ORDER UNDER SECTION 96 (2) OF ACT, III OF 1901.

With reference to ^{his}~~their~~ application, dated 13. 10. 1921.Mr. Gausf Karani is informed
Messrs. arethat the plan submitted by ^{him}~~them~~ for building a house.on plot No. 50 B. Survey Sheet K2.situate in Street, Lyari
Road

PLAN SHOWING PROPOSED BUILDING TO BE BUILT**ON PLOT N^o 50-B. SHEET N^o K.2****LYAREE QUARTER****SCALE 8'-1"**

With reference to his application dated 16th September 1921, with a plan for the proposed building on plot No. 50B, K-2 Laree Quarter, Mr. Yousif Kassim is informed, that he must produce documentary evidence to prove ownership of the plot.

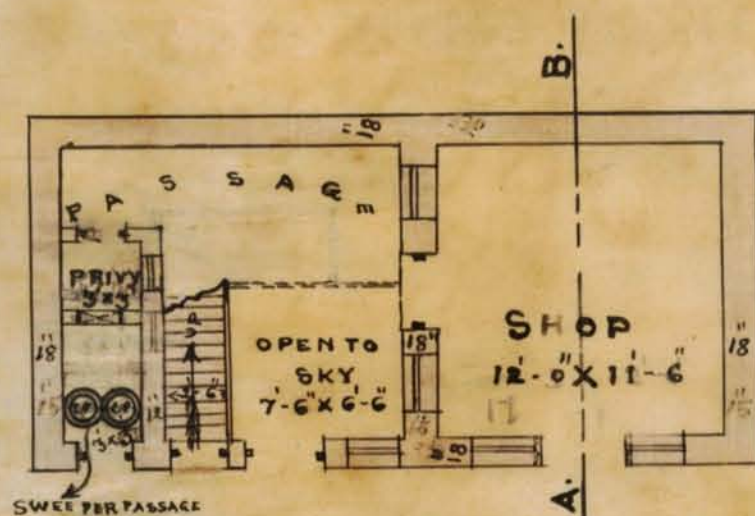
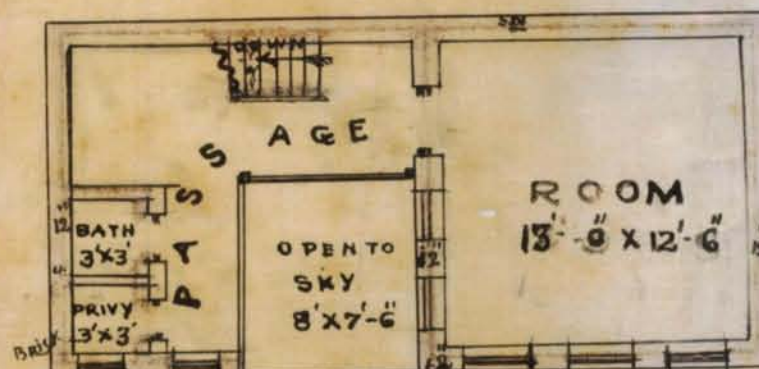
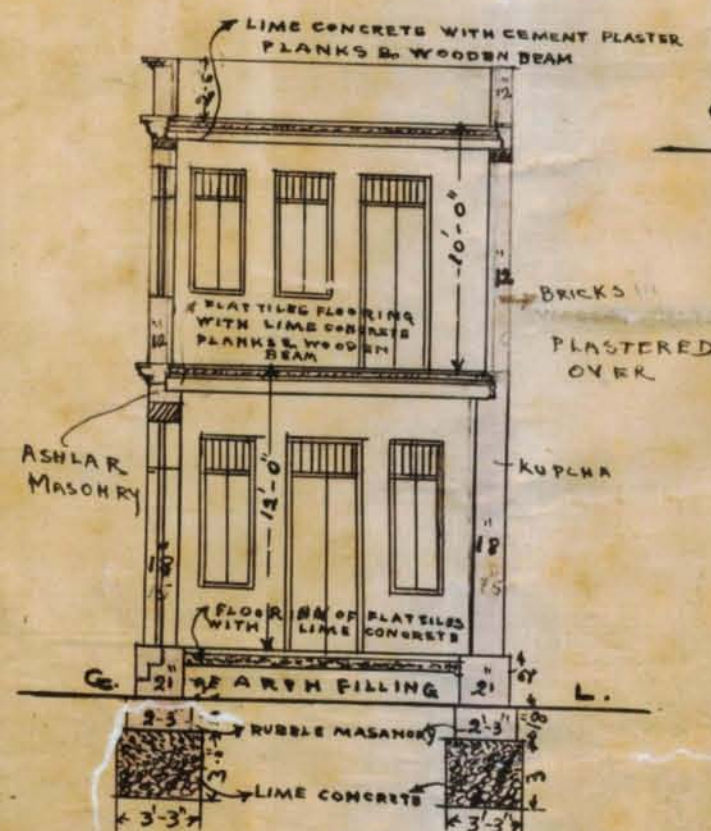
2/- The outer walls 6" thick must be increased to 12" .

3/- Catchpits for privies & bath should be separate and enough of space must be left for accomodating two catchpits and two receptacles for night soil .

Catchpits for privies & baths
should be separated & enough of
these kept for accommodation two
catchpits & two receptacles for
night soil

The ^{only} brick walls 6" thick on 1st floor must be
increased to 12" or at least to 9".

1. The outer walls have been increased from 6" to 12"

2. Two catch pits for bath & privy are provided and space 3' x 5' left for receptacles of night soil & catch pits I hope you will sanction the plans at an early date.
